**RANCH TOWN NO. 2 PUMP STATION IMPROVEMENTS PROJECT**  
**Solicitation No. CO-00599-LE**  
**Job No. 20-6005**

**ADDENDUM NO. 3**  
**October 21, 2022**

2 ELECTRODE PROBE MOUNTING AND INSTALLATION  
SCALE: NTS

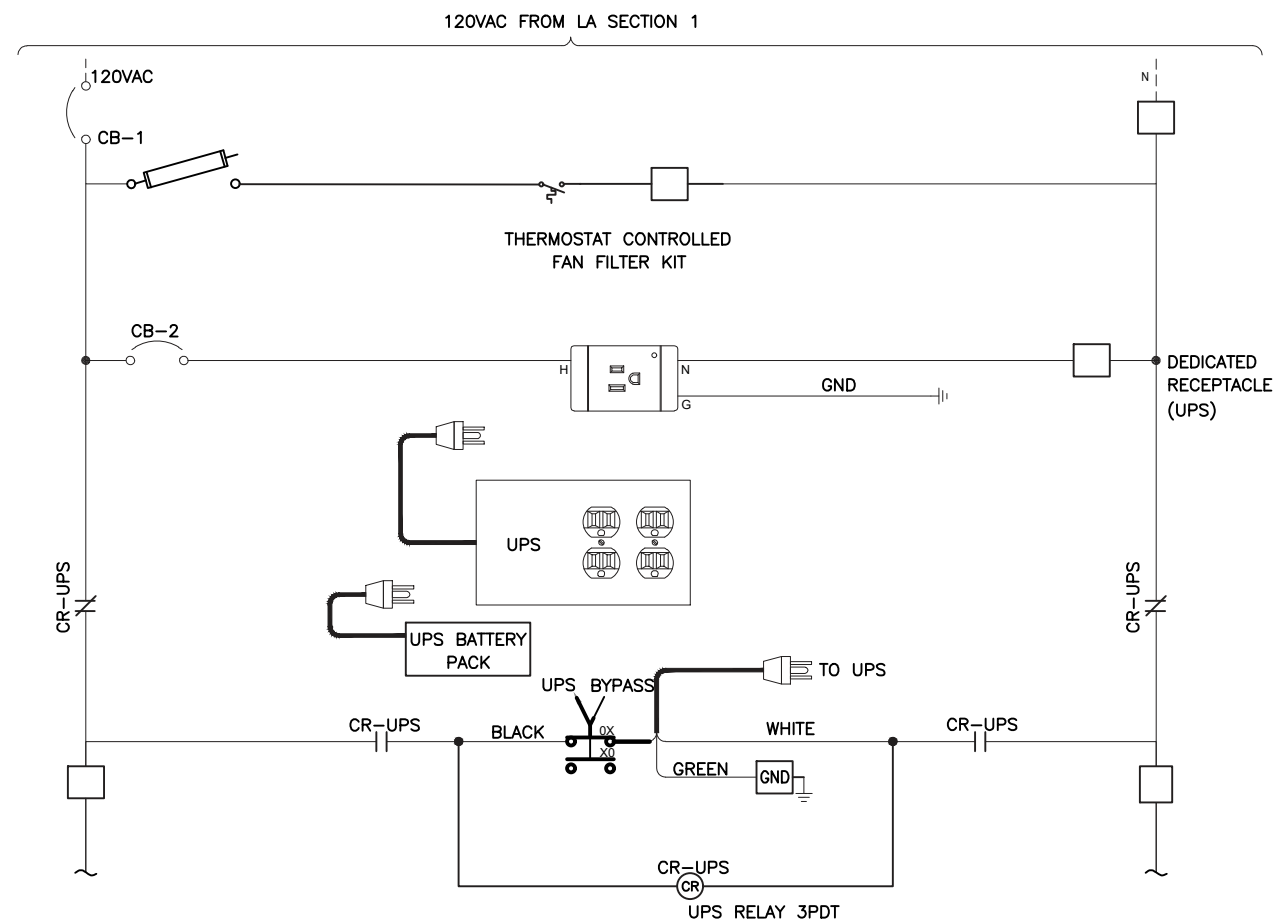
19. Question: Regarding the installation of the GST LSL-500 on the roof as shown on sheet N503 detail #2. I do not see any procedure/requirement for cutting into the roof of the GST and coating & paint touchup requirements.

*Response: According to as-built information there is an existing B/W level probe system installed at the top of the tank near the ladder. Contractor to replace B/W level probe system and obtain level switch signals from new instrument. Refer to "Changes to the Plans", Item 1f.*
